City of Albuquerque

RE: DRAINAGE PLAN FOR AN ADDITION TO HIGHLAND SENIOR CENTER
(K17-D6) ENGINEER'S STAMP DATED 3/21/94.

DRAINAGE REPORT

HIGHLAND SENIOR CENTER IMPROVEMENTS

GRADING AND DRAINAGE PLAN

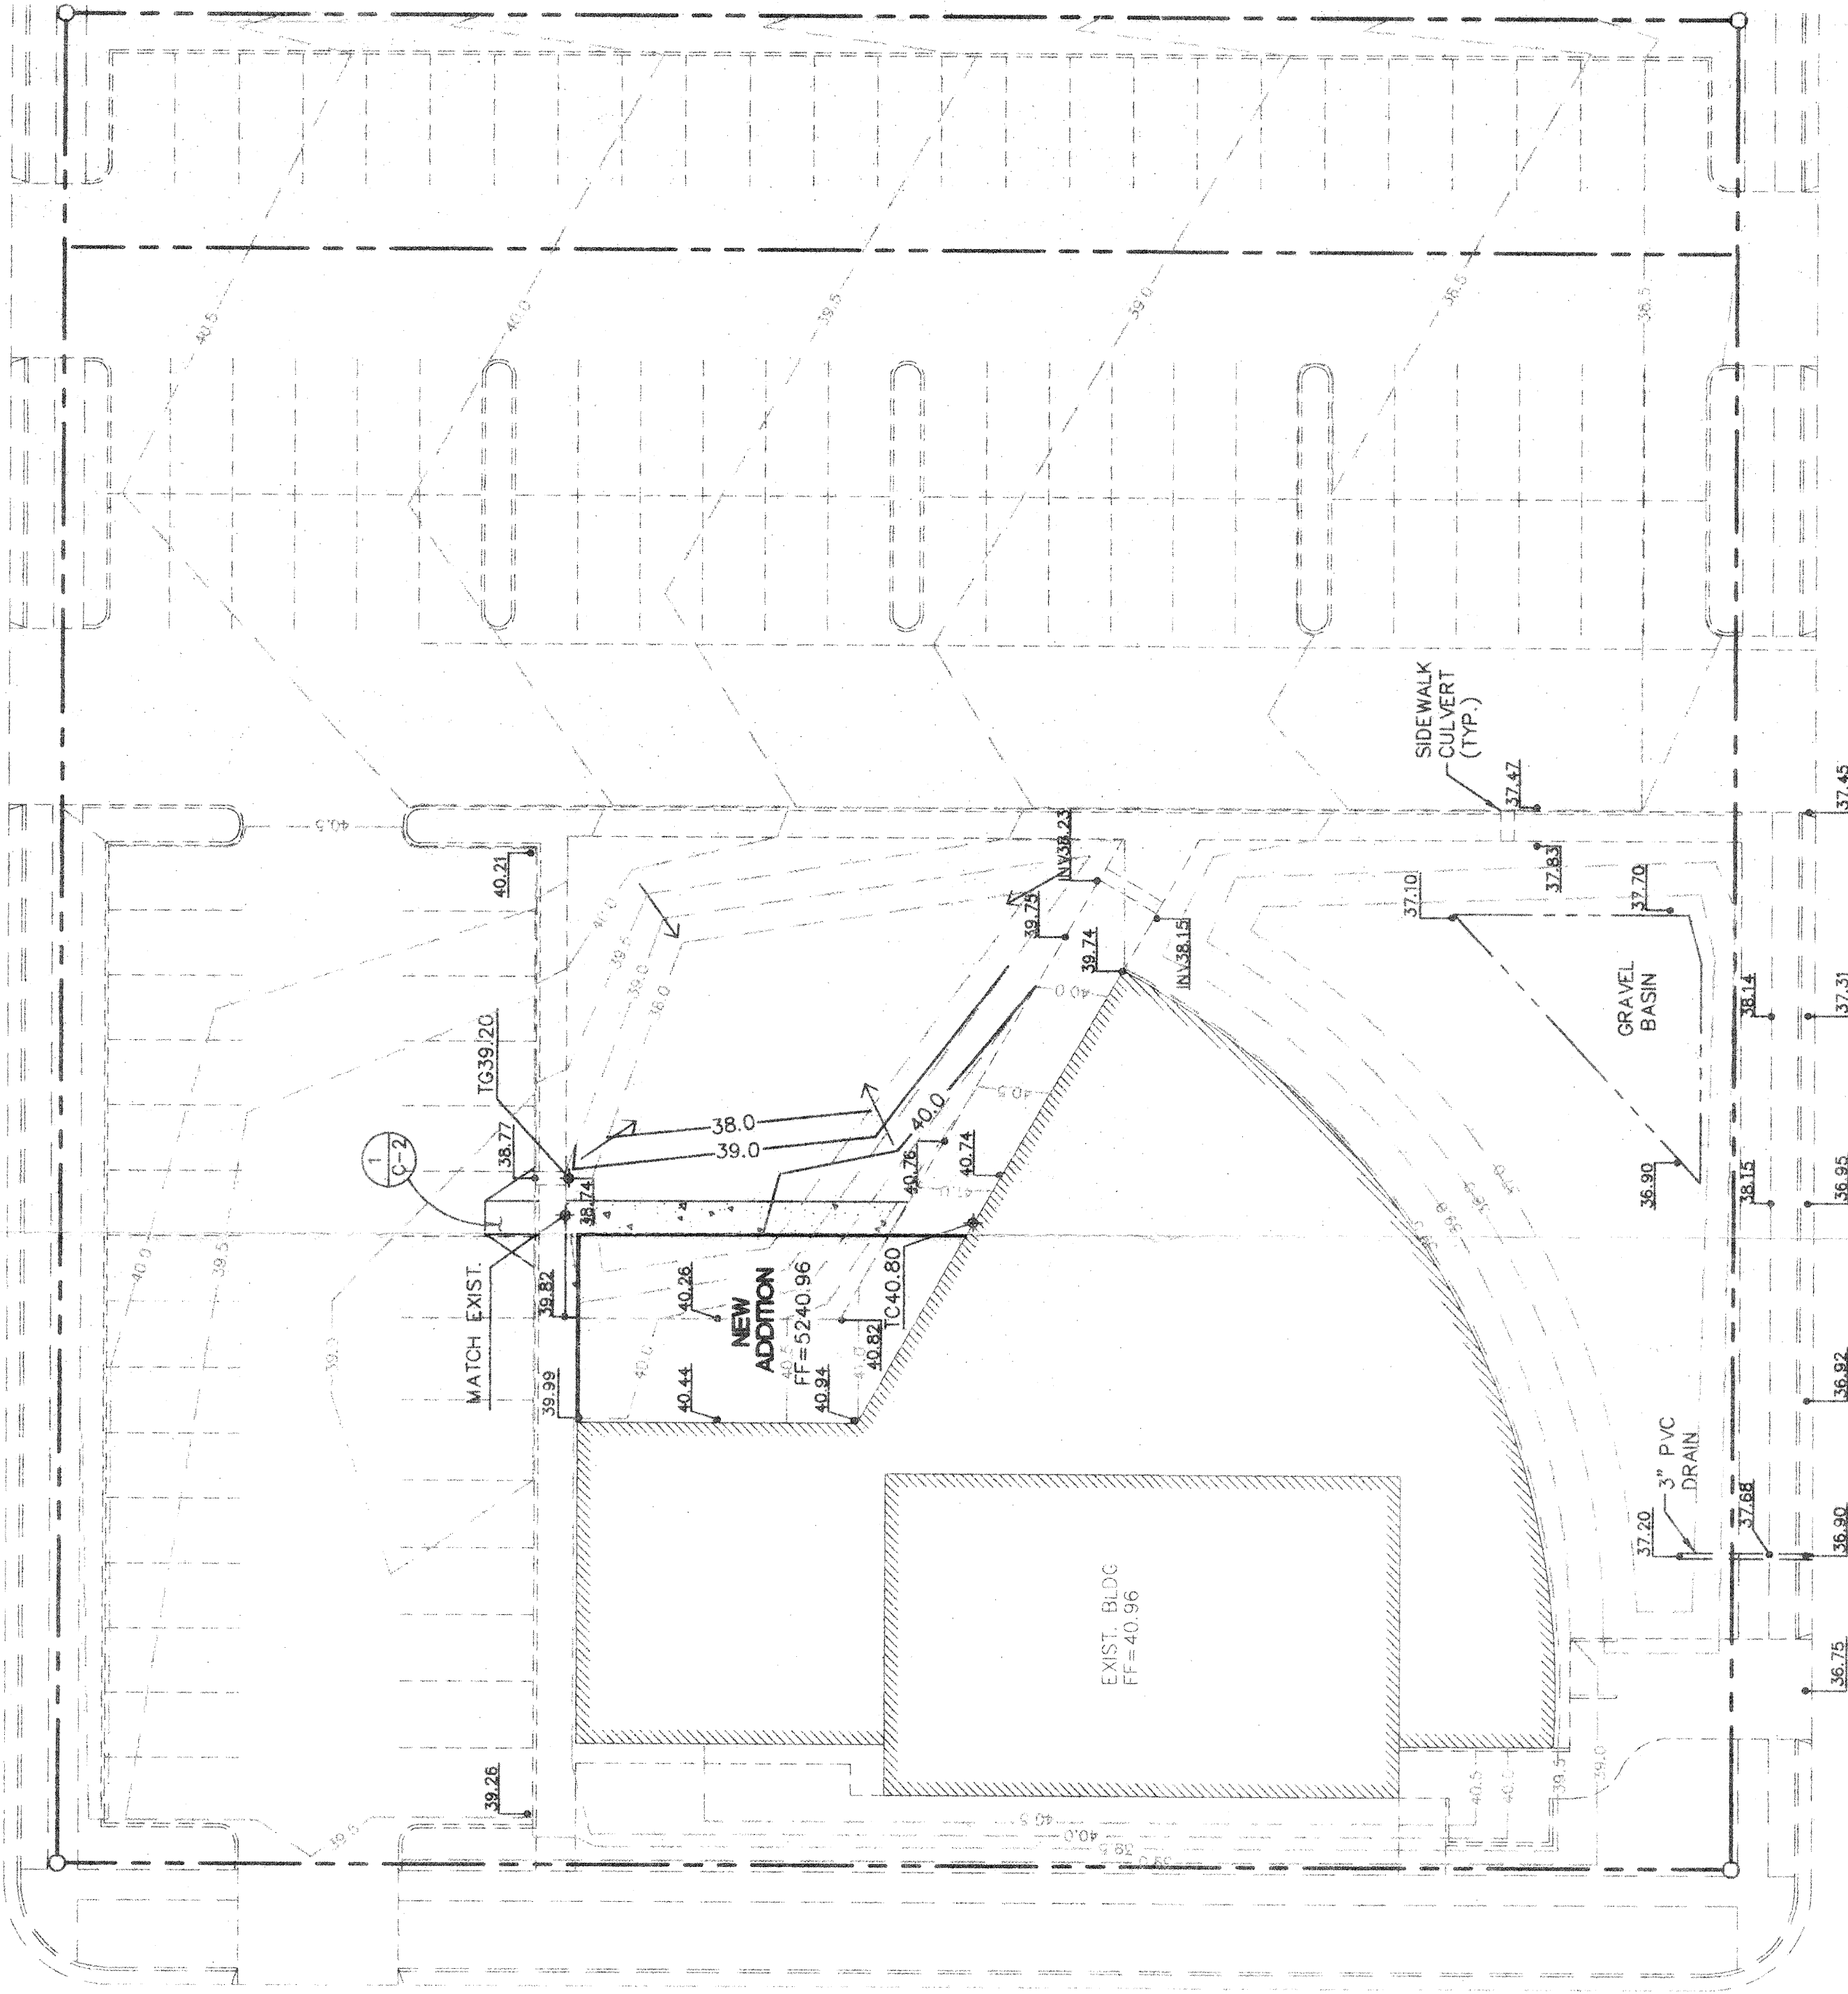
Based on the information provided on your April 26, 1994 submittal, the above referenced site is approved for Foundation and Building Permit.

Please attach a copy of this approved plan to the construction sets prior to sign-off by Hydrology.
